SITE SUPPLEMENTAL INSTRUCTION

PROJECT: Forestside Estates
Attmar & Palleschi Drive
Brampton, ON

SITE SI NO. M-2

PURPOSE: To revise mechanical layout to suit architectural SI A-01 and City comments.

DRAWN MC	CHECKED LM	SCALE 1:50
DATE MAY, 2019	PROJECT 18-017	DRAWING M-46
		OF -

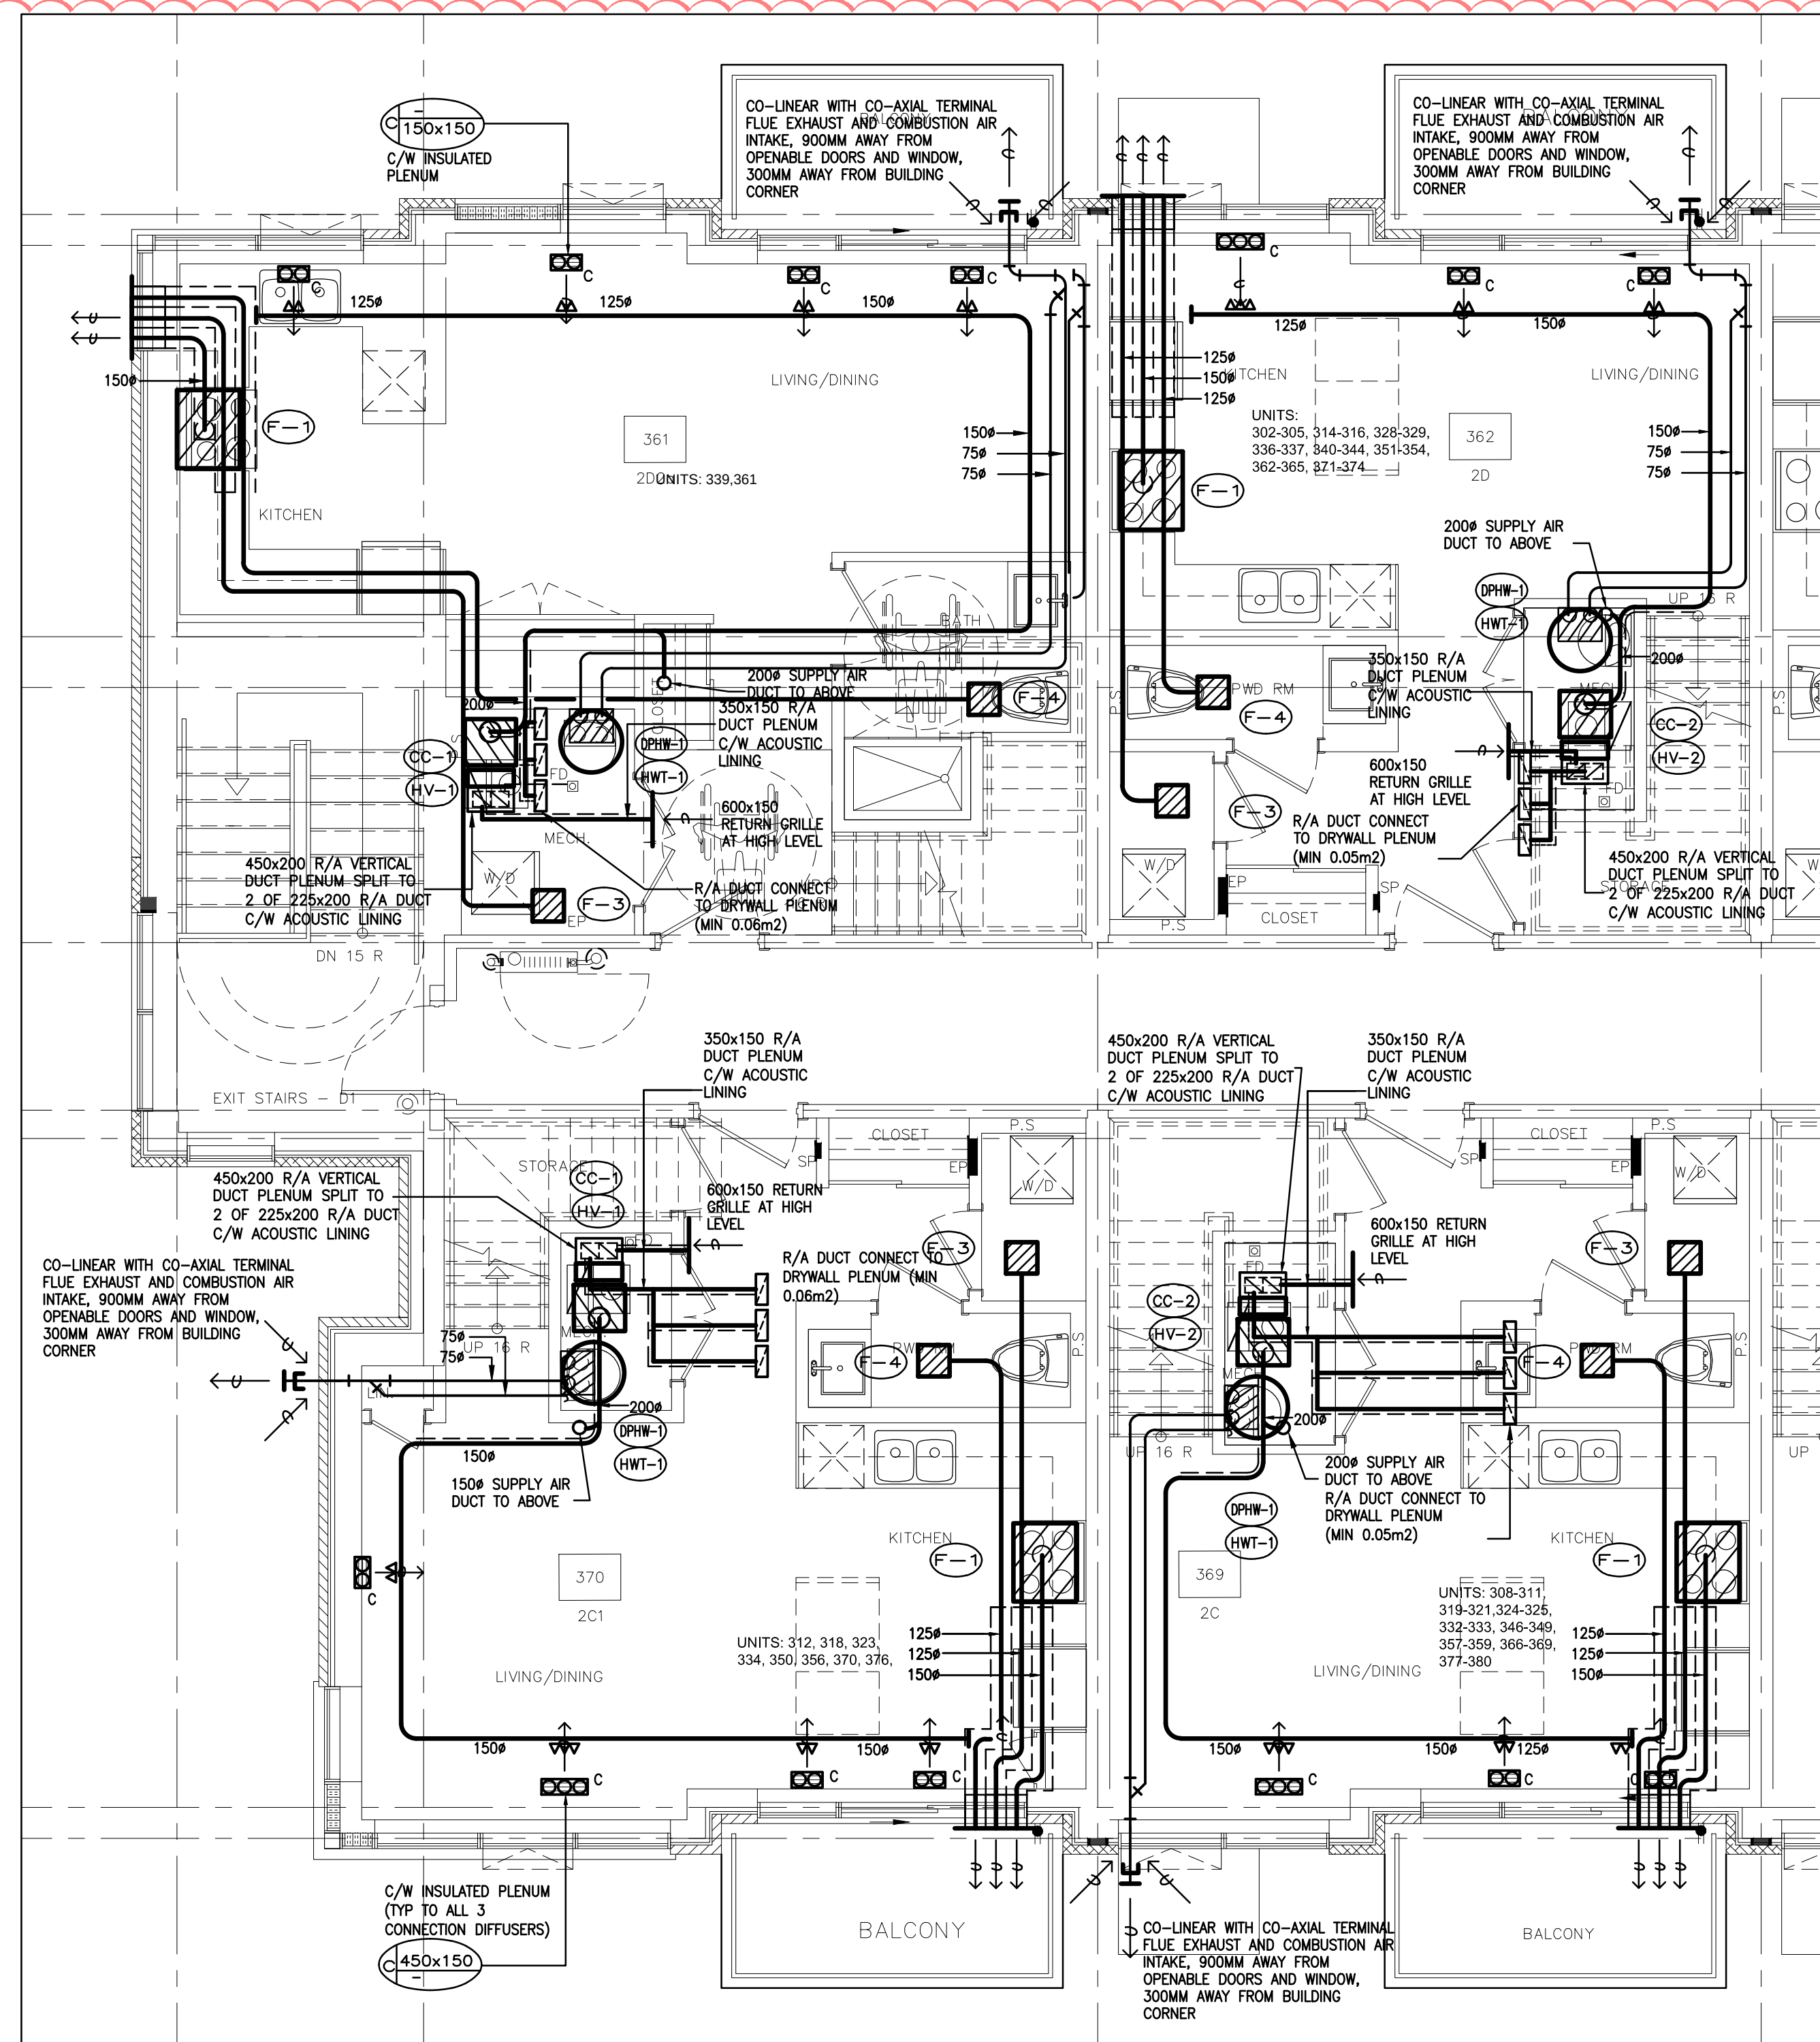
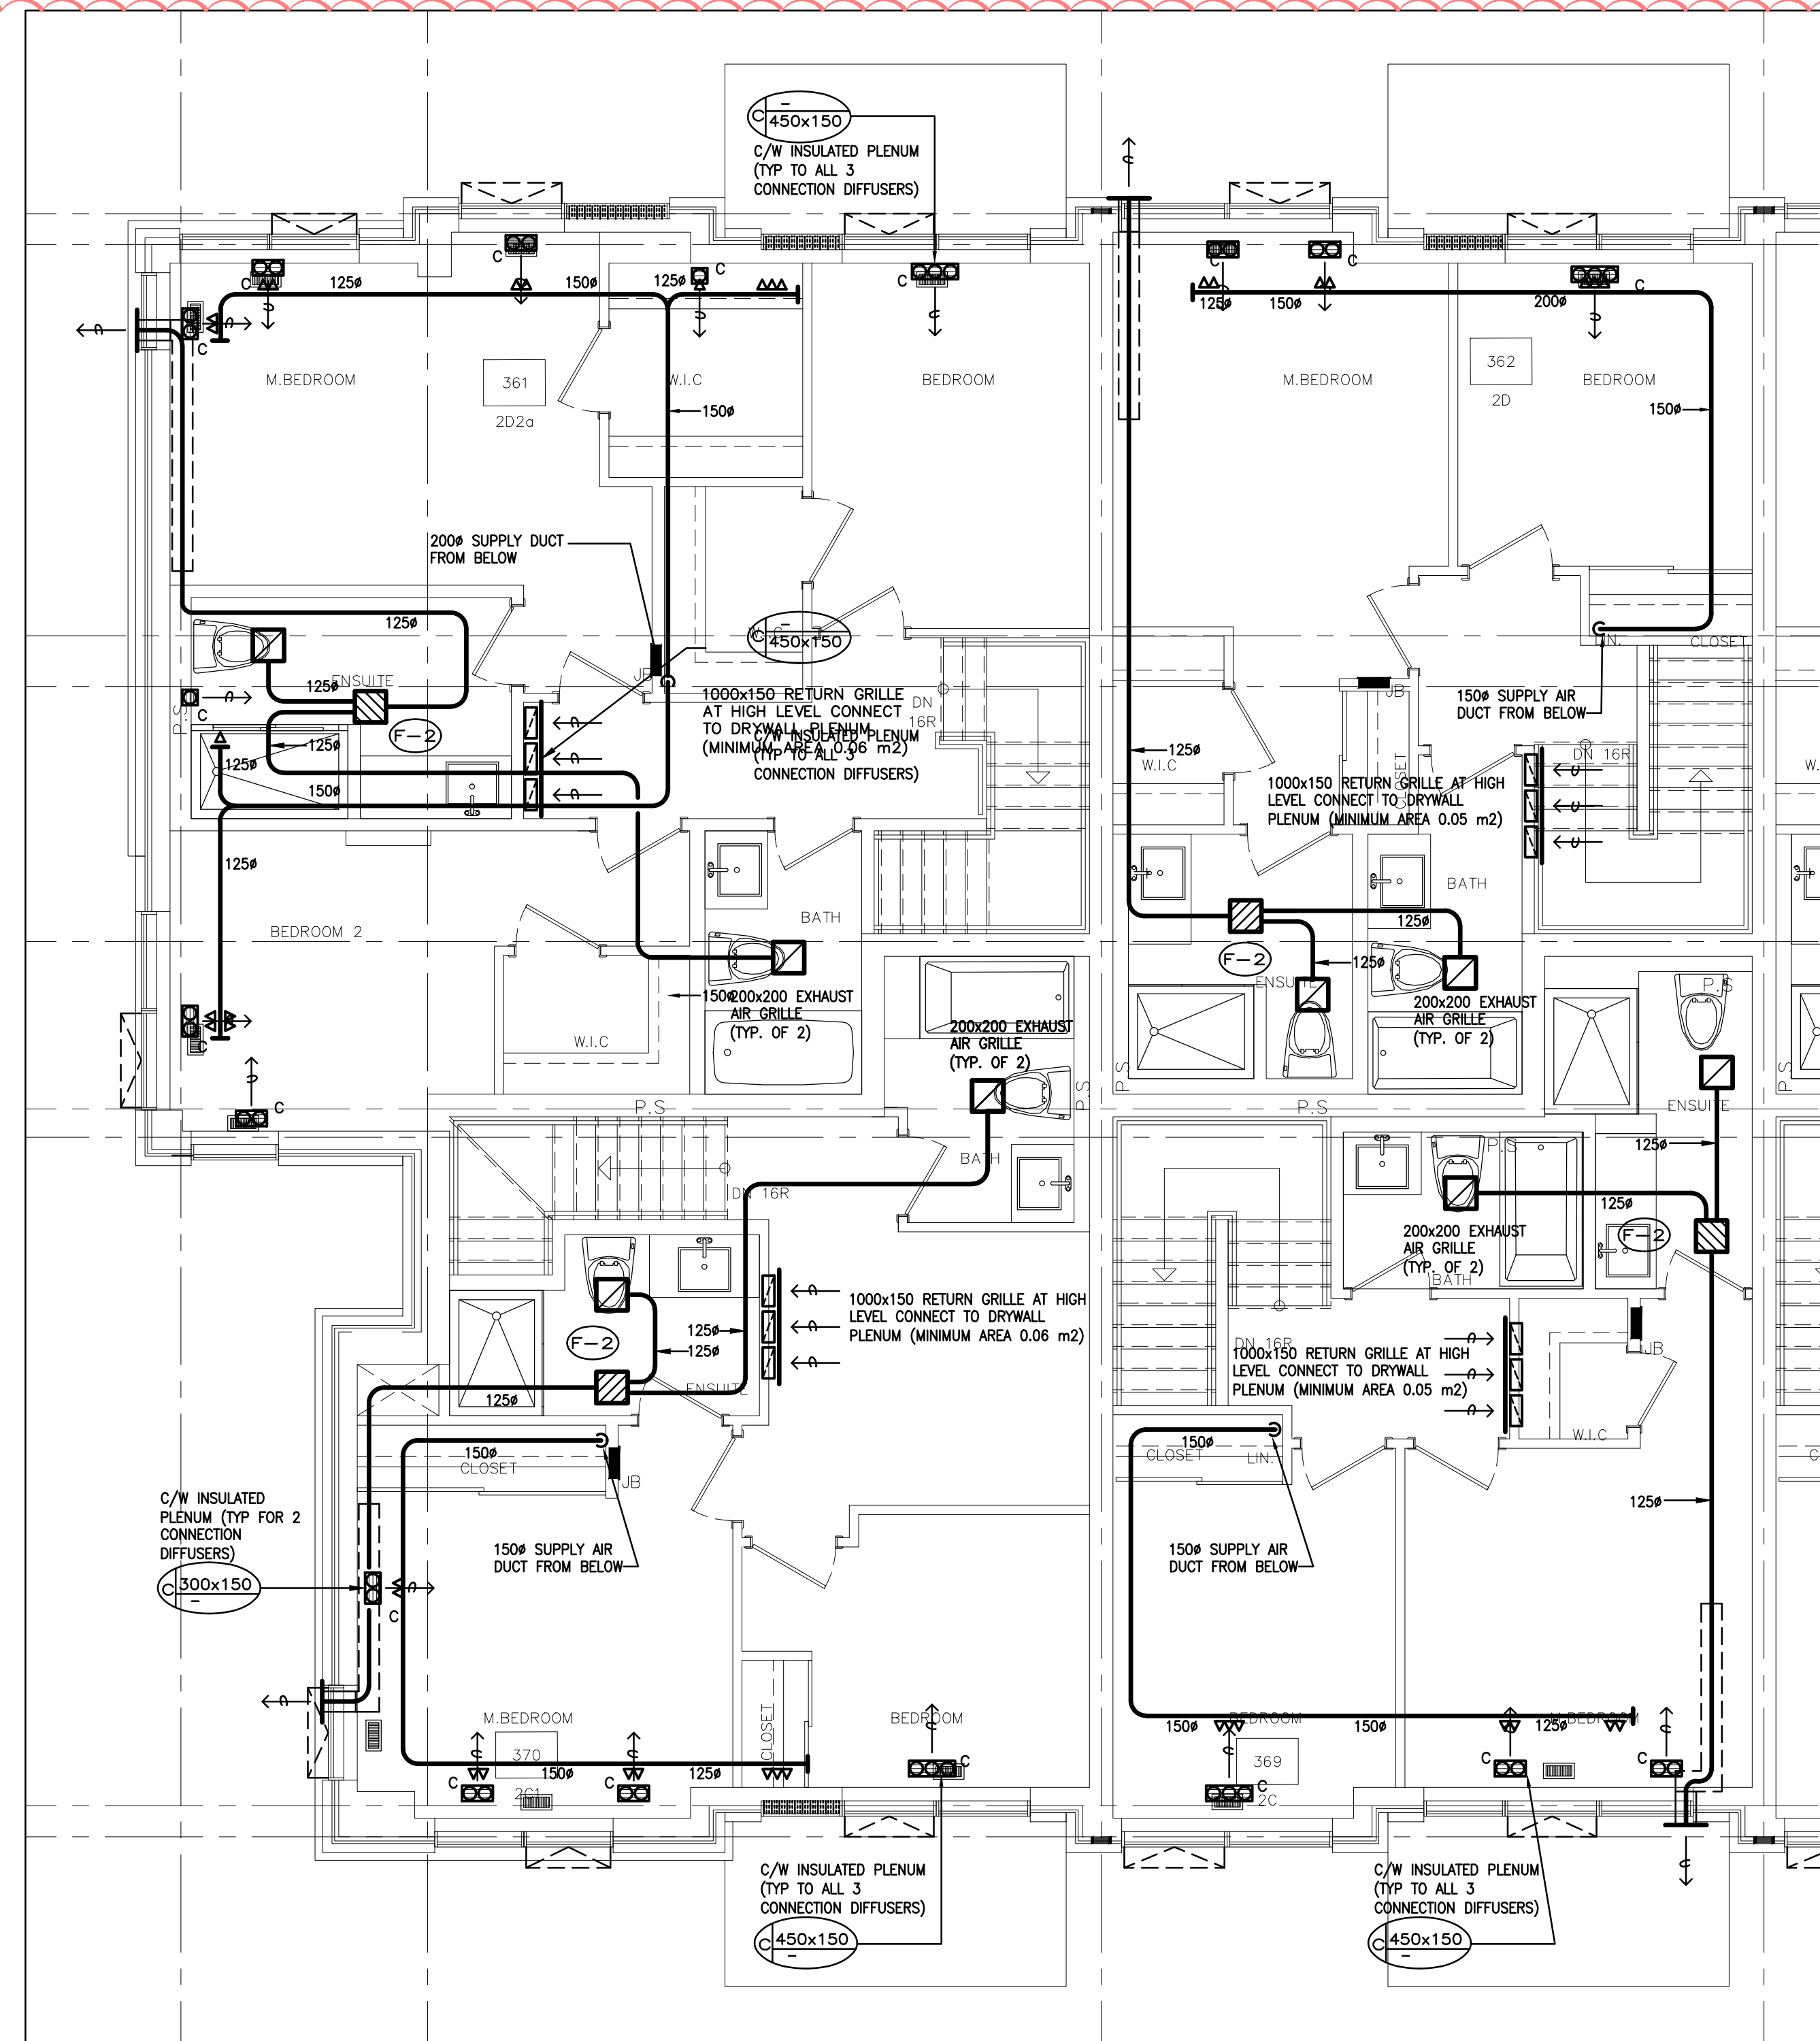
7.0 Reference Drawing M-45,M-46,M-47 (Typical Units - Mechanical) Issued

7.1 Added: Typical suite layout 2A1-R,2A-R and 2Aa-R.

7.2 Revised: Typical suite 2A,2A1,2Aa ,2Ab, 2A4,2A2,2A3,2A2a kitchen exhaust location according to code requirements.
